GRADING AND EROSION CONTROL PLAN  
APPALOOSA HIGHWAY 24 SUBDIVISION FILING NO. 2  
EL PASO COUNTY, COLORADO

APPALOOSA HIGHWAY 24 SUBDIVISION

FILING NO. 1A

COVER SHEET

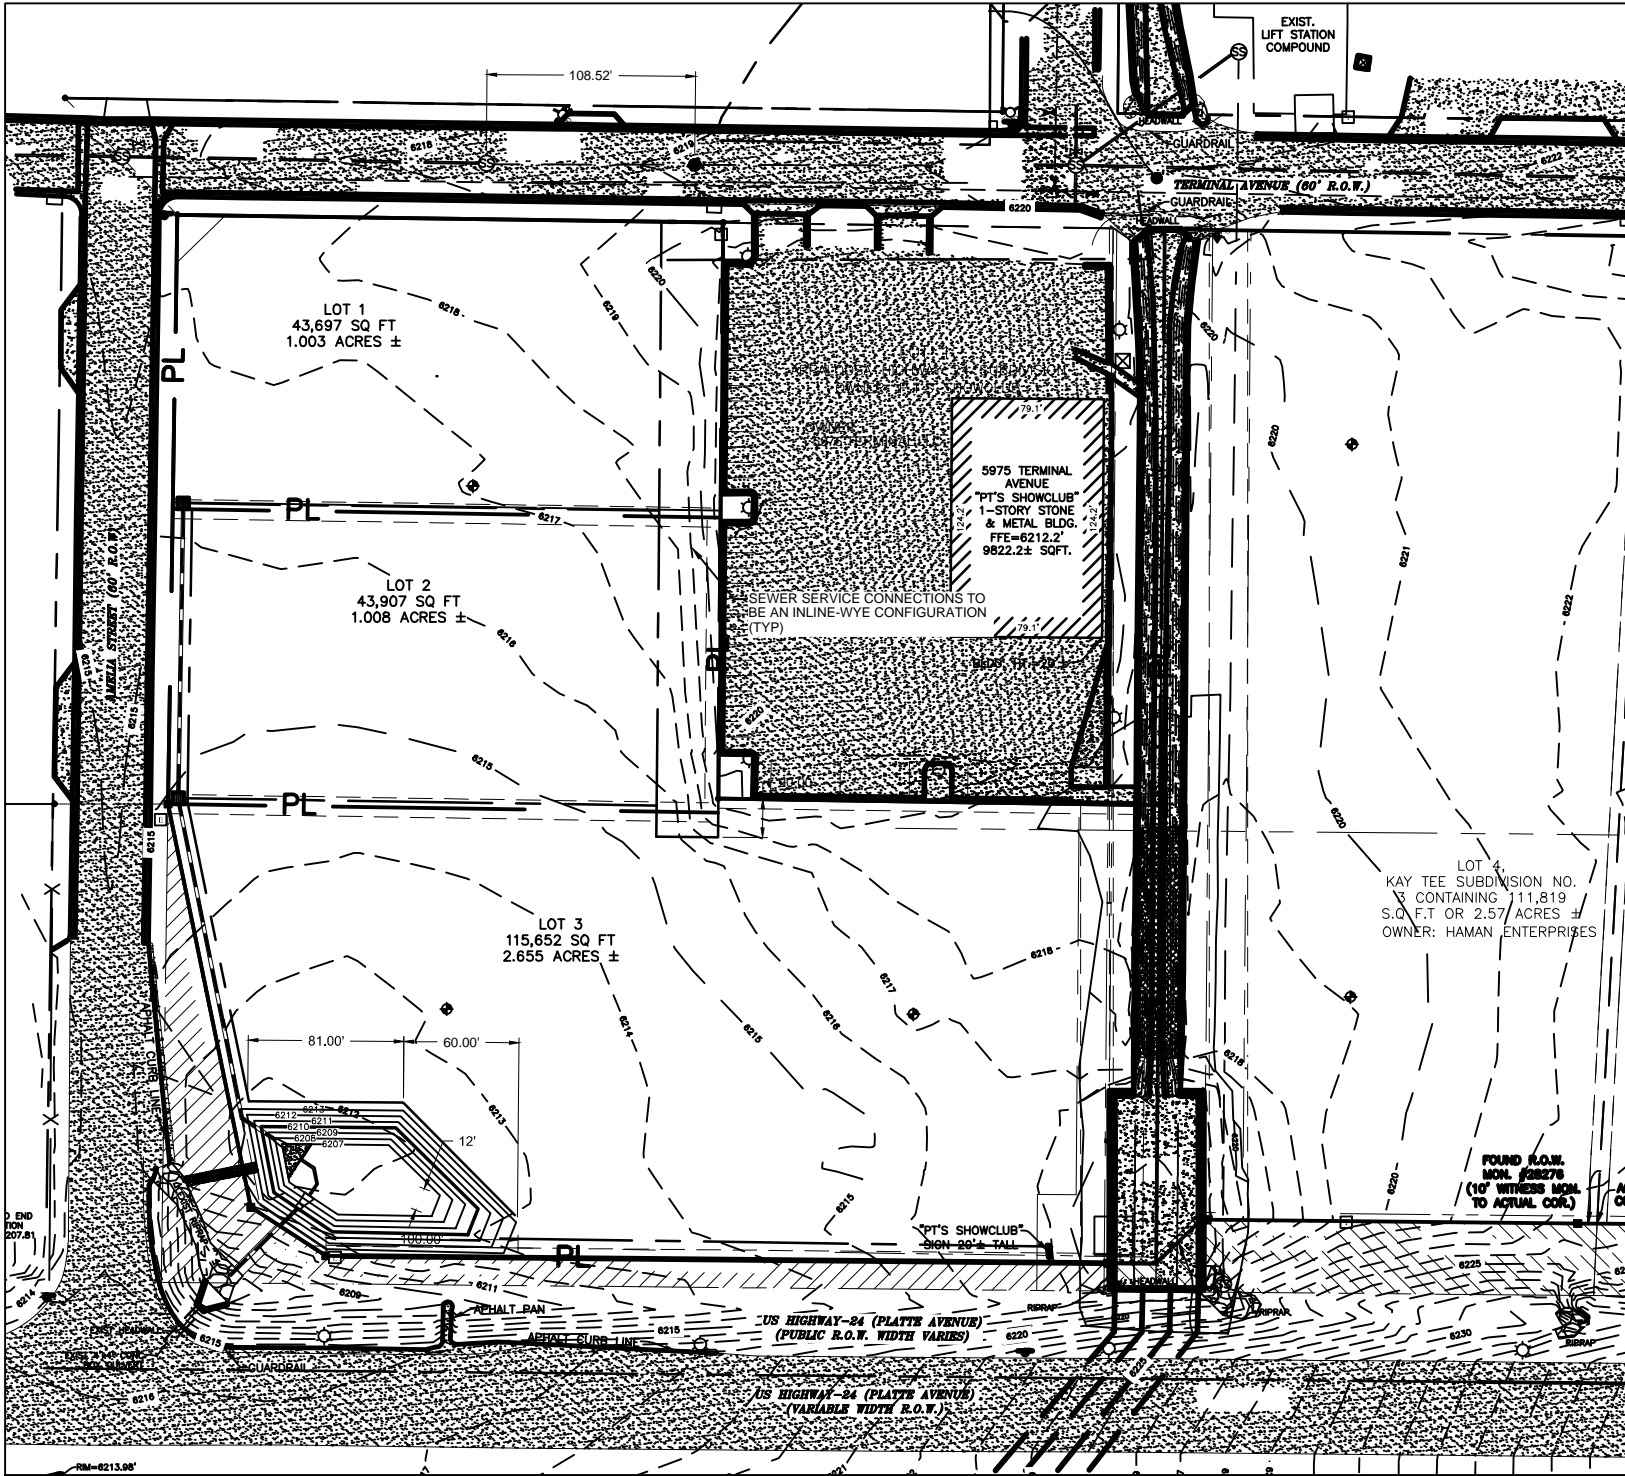
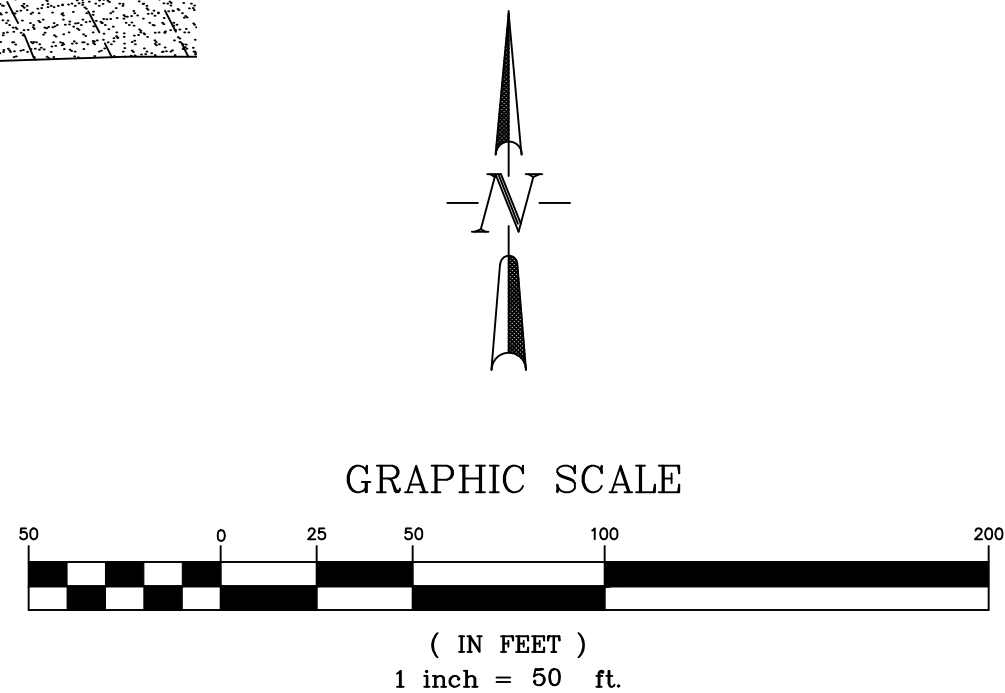
See comments on GEC Plan submittal and make appropriate changes.
